ADDENDUM No. 2
December 10, 2025

CALAVERAS COUNTY WATER DISTRICT
ARNOLD WWTP IMPROVEMENTS PROJECT

This Addendum No. 2 ("Addendum") as dated above modifies certain Bidding Documents issued by the Calaveras County Water District in connection with the District's Arnold WWTP Improvements Project. There are no other amendments to the Bidding Documents other than expressly contained in this and any other Addenda issued by the District.

E101
DRAWING NUMBER
SHEET 61 OF 76

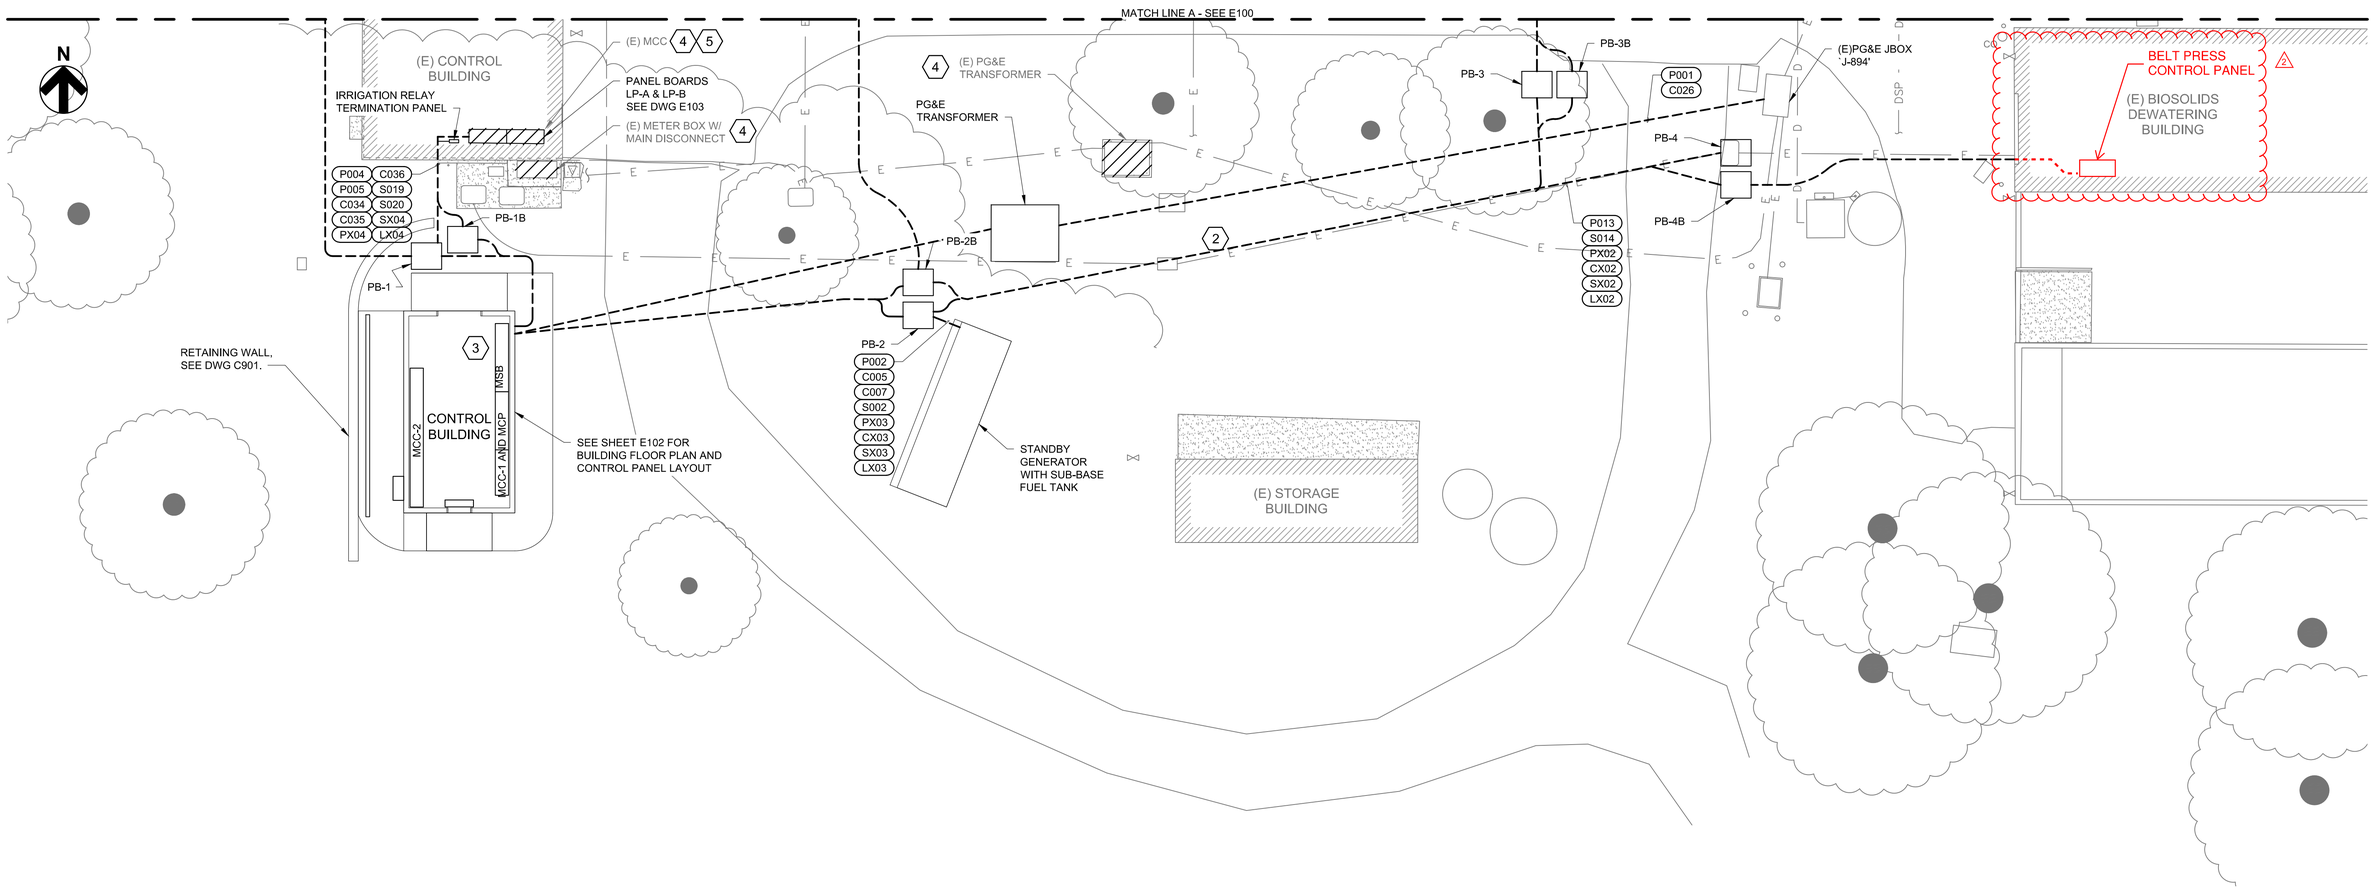
1. **Question:** Requests made for additional detail on electrical and controls scope from PB-4B to the interior of the Existing Biosolids Dewatering Building shown on Drawing E101 and to the belt press control panel.
   Answer: See Addendum #2 revisions to Sheet E-101.

j. Belt Press Main Panel 'LCP1' **Answer:** Belt Press Main Panel 'LCP1' is located in existing Biosolids Dewatering Building shown on E101.

E102
DRAWING NUMBER

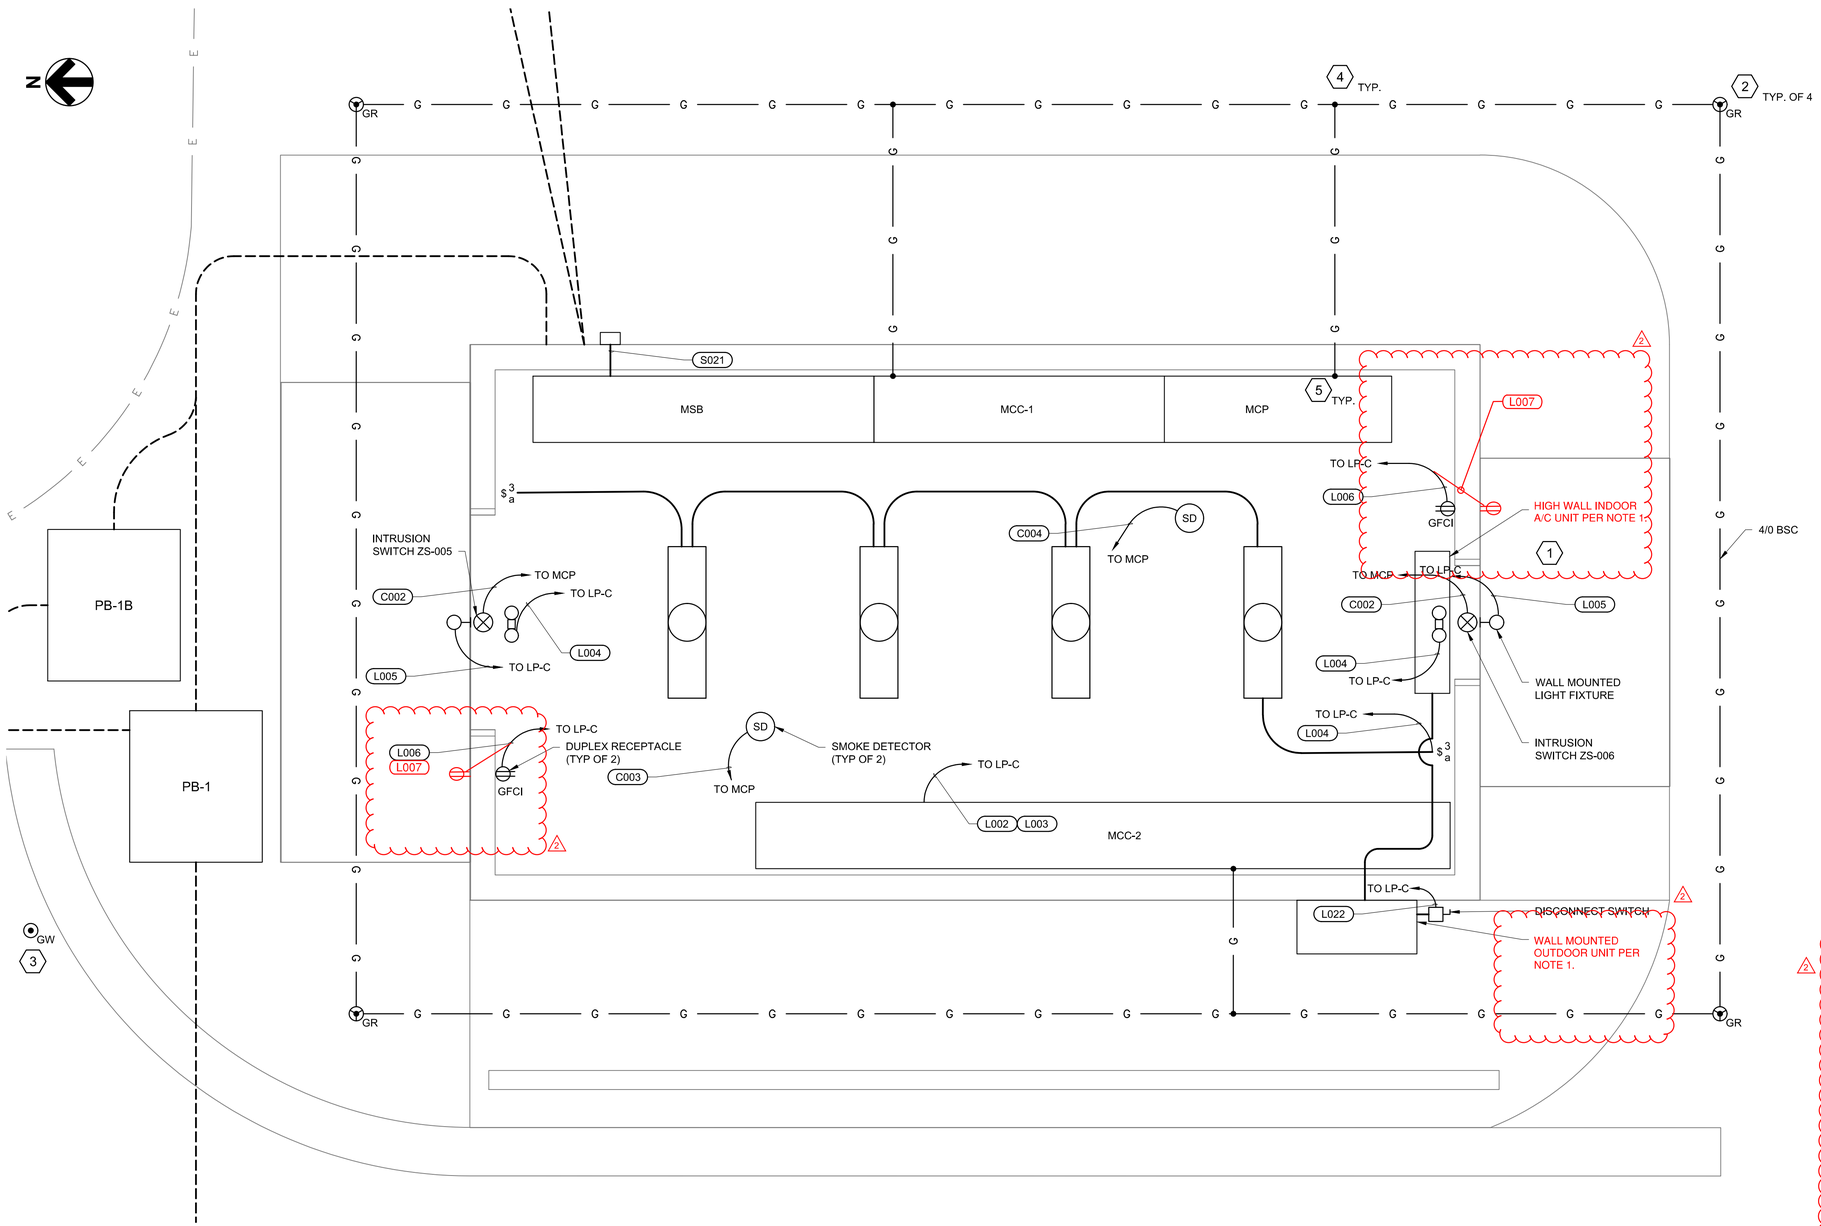
26. **Question:** Drawing E102 calls for an HVAC split system (Carrier Model 40MAHBQ24XA3 Indoor Unit/38MARBQ24AA3 Outdoor Unit). Please confirm whether OR EQUAL models will be acceptable. Will there be a specification section for the HVAC scope?
    Answer: See Addendum #2 changes to E102.

27. **Question:** For the HVAC split system on drawing E102, will there be a specification section for the refrigerant piping and condensate piping? Will pre-insulated line-sets be acceptable for the refrigerant piping? Schedule 40 PVC for the condensate piping?
    Answer: See Addendum #2 changes to E102.

34. **Question:** E022 has conduit L007 (Control Room exterior receptacle). Drawing E102 doesn't show any. How many would you like?
Answer: Two circuits provided for receptacles (interior/exterior). Provide exterior receptacle directly behind the interior receptacles. See Addendum #2 changes to E102.

1. HIGH WALL INDOOR A/C UNIT TO BE MOUNTED TO WALL ABOVE DOOR. UNIT SHALL BE CARRIER MODEL 40MAHBQ24XA3 INDOOR UNIT OR APPROVED EQUAL. WALL MOUNTED OUTDOOR UNIT SHALL BE MOUNTED 4' ABOVE GRADE AND SHALL BE CARRIER MODEL 38MARBQ24AA3 208/230V - 1 - 60 OR APPROVED EQUAL.

2. GROUND ROD CONNECTIONS PER DETAIL 4/E900.
3. GROUND TEST WELL PER DETAIL 4/E901.
4. BELOW GRADE EXOTHERMIC WELD CONNECTION PER SPECIFICATION SECTION 16450.
5. EQUIPMENT BOND PER SPECIFICATION SECTION 16450.
6. PROVIDE SCHEDULE 40 PVC CONDENSATE PIPING. PRE-INSULATED LINE SETS ARE ACCEPTABLE AND SHALL MEET THE FOLLOWING REQUIREMENTS: COPPER: ASTM B280 ACR; INSULATION: NBR/PVC CLOSED-CELL ELASTOMERIC, 3/4" MINIMUM; JACKET: UV-RESISTANT BLACK POLYETHYLENE.

E500
DRAWING NUMBER

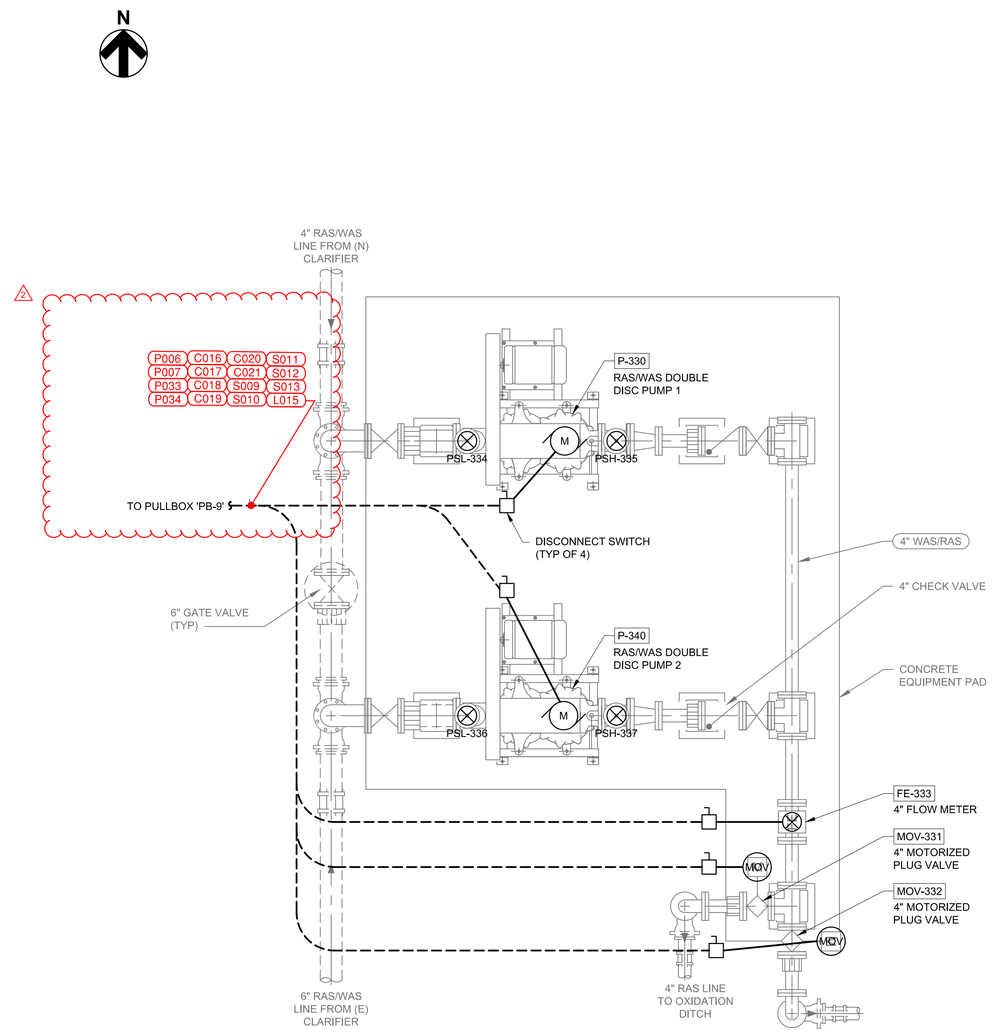
7. **Question:** Requests for clarification made relating to conduit identifiers the RAS/WAS pump station on E500.
   Answer: See Addendum #2 changes to Sheets E100 and E500.

24. **Question:** Conduits P008 and P009 are referenced on drawing E100 as routed to the RAS/WAS area. The conduit and conductor schedule calls for these conduits to be routed to Plug MOV 3 & 4 (Future). There is no reference of the conduits or future MOV's on drawing E500. Please provide the location of the future MOV's.
    Answer: See Addendum #2 changes to Sheets E100 and E500.

1. NEW RAS/WAS PUMP STATION ELECTRICAL AND SIGNAL CONDUITS SHALL BE ROUTED UNDERGROUND TO PULLBOX 'PB-9'.
